CCB 8000
Pre and Post Change Summary
PCN #: MFOL-22GSIN584

Pre and Post Change Summary – T/R (Carrier Tape)

Pre and Post Change Summary – Tube (Static Shielding Bag)

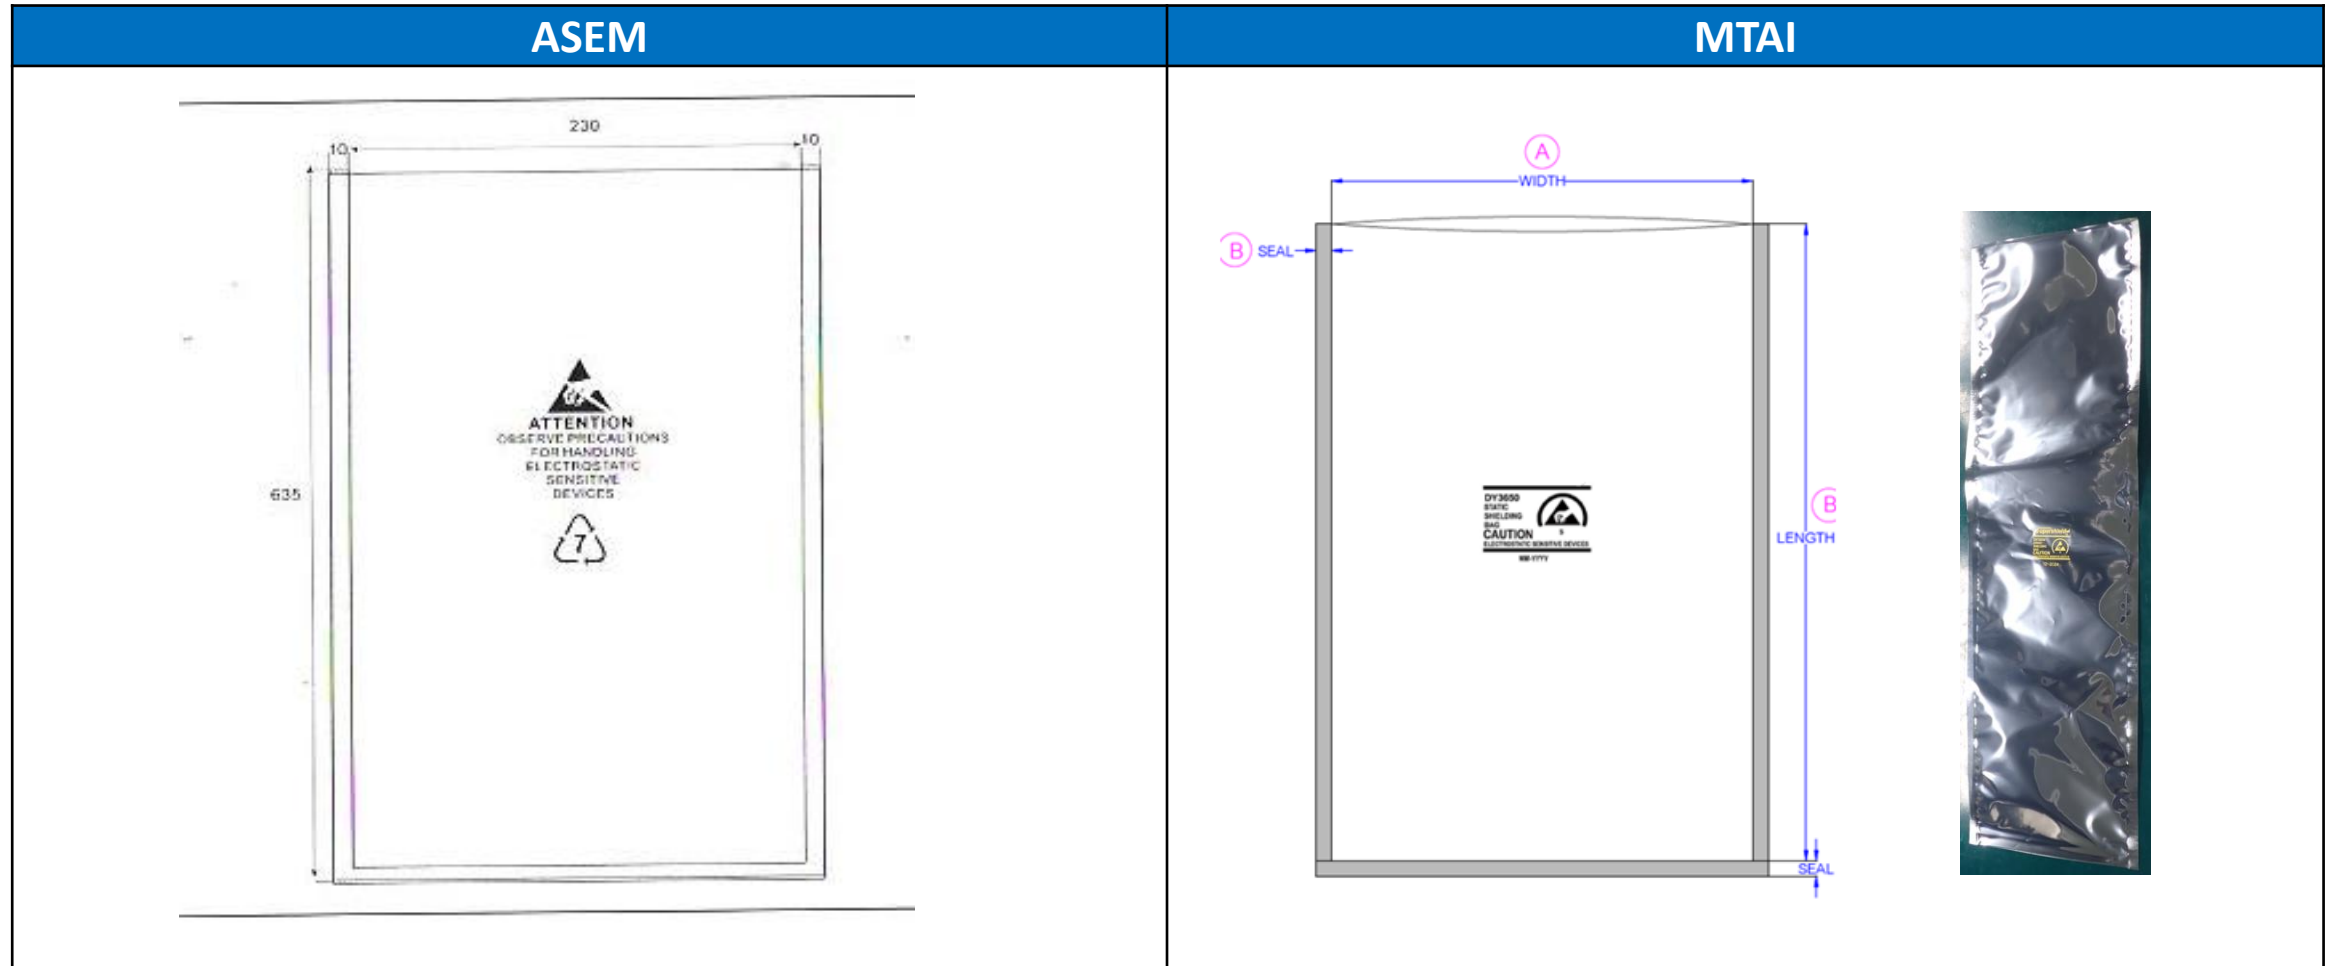
Plant	Bag type	Length (mm)	Width (mm)	Thickness (mm)
ASEM	Static Shielding Bag	635.00±5.00	230.00 ±5.00	0.0762
MTAI	Static Shielding Bag	650 +5/-0	160 +5/-0	0.0762
